## HISTORIC AND DESIGN REVIEW COMMISSION

**HDRC CASE NO:** 2020-468  
**ADDRESS:** 1009 S ALAMO ST  
**LEGAL DESCRIPTION:** NCB 744 BLK 3 LOT 3 & W 5.1 FT OF 2  
**ZONING:** C-3 IDZ, H  
**CITY COUNCIL DIST.:** 1  
**DISTRICT:** King William Historic District  
**APPLICANT:** Kelly Welker/Welker Financial LTd and Bijous Betties  
**OWNER:** 1009 S ALAMO LLC  
**TYPE OF WORK:** Construction of rear accessory structures, ADA ramp installation, landscaping and site modifications  
**APPLICATION RECEIVED:** October 16, 2020  
**60-DAY REVIEW:** Not applicable due to City Council Emergency Orders  
**CASE MANAGER:** Huy Pham  
**REQUEST:**

The applicant is requesting approval to construct a 30' by 12' prefabricated accessory structure in the rear yard.

## Order Information

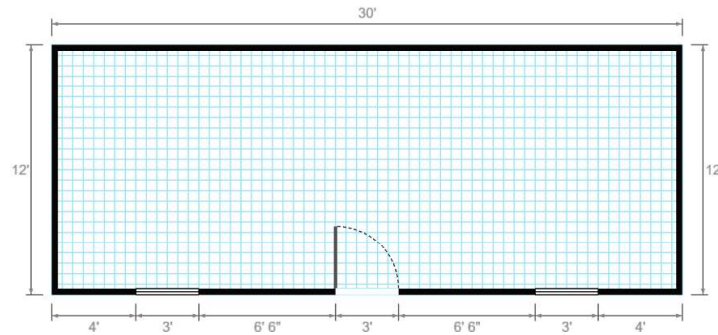
- c. REAR ACCESSORY STRUCTURE – The applicant has proposed to install a prefabricated 30-foot wide, 12-foot deep, and 8' tall rear accessory structure with aluminum windows and doors, T-111 plywood panel siding, and a v-crimp metal roof and full width wood porch.

- f. CHARACTER – The proposed rear accessory structure features T1-11 plywood panel siding, and a v-crimp metal roof and full width wood porch with simple square columns and 1x6 wood plank decking. Per the Guidelines for New Construction 5.A.iii., Relate new garages and outbuildings to the period of construction of the principal building on the lot through the use of complementary materials and simplified architectural details. Staff finds that the v-crimp metal roof and simple wood construction porch decking and columns are appropriate for a rear accessory structure. However, staff finds that horizontal wood lap or smooth Hardie lap siding with 4 inch exposure or vertical board-and-batten siding with 12 inch panels to be more appropriate than the T1-11 plywood panel siding.

- g. WINDOWS & DOORS – The proposed rear accessory structure features aluminum windows with faux divided lites and a 9-lite aluminum door. Per the Guidelines for New Construction 5.A.iv., applicants should design window and door openings to be similar to those found on historic garages or outbuildings in the district or on the principle historic structure in terms of their spacing and proportions. Staff finds the proposed steel door with a true divided 9-lite design to be appropriate. However, staff finds that the proposed windows do not adhere to *Standard Specifications for Windows for New Construction* regarding trim, sash profiles, faux divided lites, and nailing fin installation.

- i. That the windows adhere to *Standard Specifications for Windows for New Construction* instead of the proposed windows which are non-conforming in trim, sash profiles, faux divided lites, and nailing fin installation. An appropriate window product must be submitted to staff for verification prior to purchase and installation.
- ii. That the siding feature complementary materials such as horizontal wood lap or smooth Hardie lap siding with 4 inch exposure or vertical board-and-batten siding with 12 inch panels – instead of the proposed tan the T1-11 plywood panel siding. If Hardie or similar quality composite material is used, no faux wood grain texture should be used.
